Module Receiver Interference Tolerance Test Revisited

D2.3 comment #58 & #60

Introduction – comment #58 & 60 from D2.3

Figure 176D-7b—Host test channel calibration

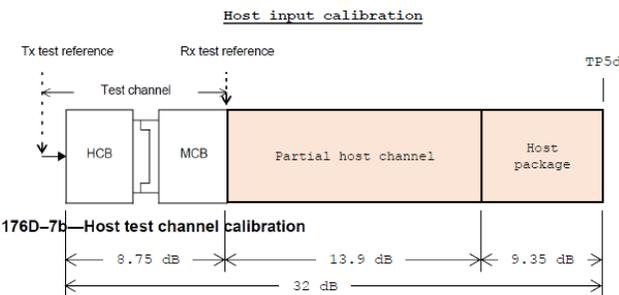
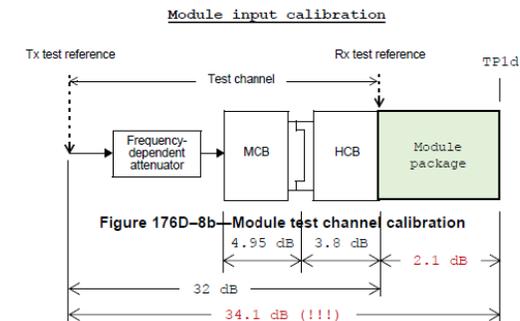
D2.3 interference tolerance test calibration

- For the host test, the test channel is measured between the Tx and Rx test references shown in Figure 176D-7b, and COM is calculated using the partial host channel, device package, and device termination models in Table 176D-6 for the receiver S-parameter model.
- For the module test, the test channel is measured between the Tx and Rx test references shown in Figure 176D-8b, and COM is calculated using the module device package and device termination models in Table 176D-6 for the receiver S-parameter model. Calculation is performed for both case 1 and case 2 of the package transmission line 1 length, and the value of COM is taken as the lower of the two calculated values.

Assumed module loss is too high!

Correction to interference tolerance test calibration

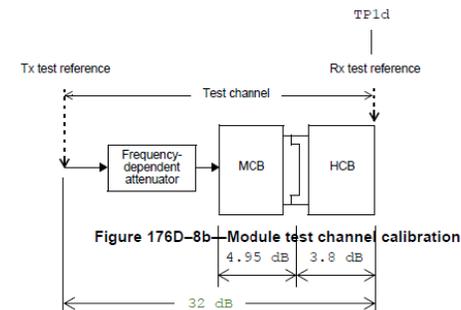
- For the host test, the test channel is measured between the Tx and Rx test references shown in Figure 176D-7b, and COM is calculated using the partial host channel, device package, and device termination models in Table 176D-6 for the receiver S-parameter model.
- For the module test, the test channel is measured between the Tx and Rx test references shown in Figure 176D-8b, and COM is calculated using the ~~module device package and device termination models in Table 176D-6 for the receiver S-parameter model. Calculation is performed for both case 1 and case 2 of the package transmission line length, and the value of COM is taken as the lower of the two calculated values.~~

Corrected specification limits

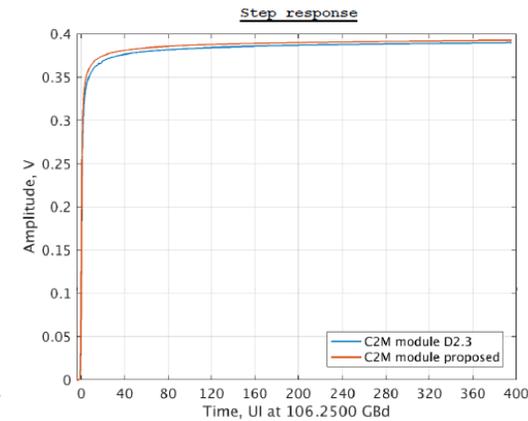
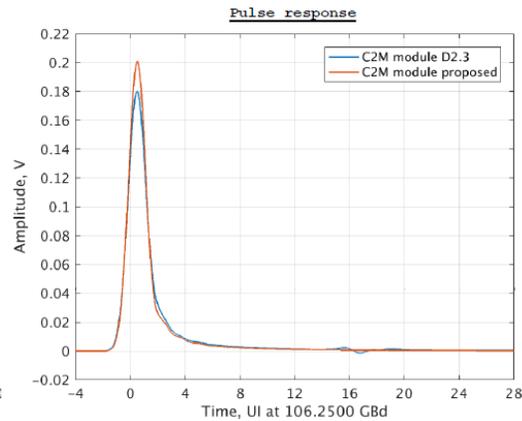
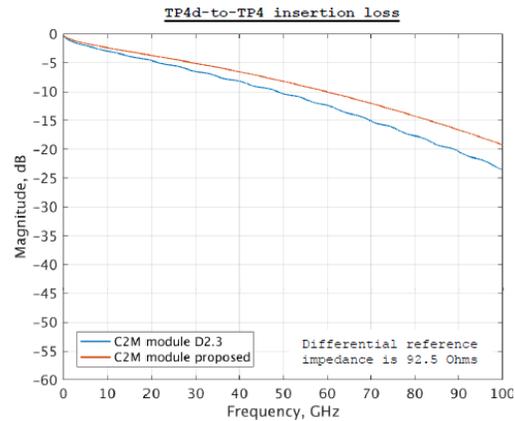
Specification limits recalculated using the corrected model

Case	Package		Insertion loss, dB		P_{max} , V	v_f , V	R_{peak}
	Class	Length, mm	Mated test fixture	TP4d-to-TP4			
C2M module, D2.3	A	10	8.75	10.82	0.179	0.389	0.46
C2M module, proposed	n/a	n/a	8.75	8.75	0.2	0.392	0.51
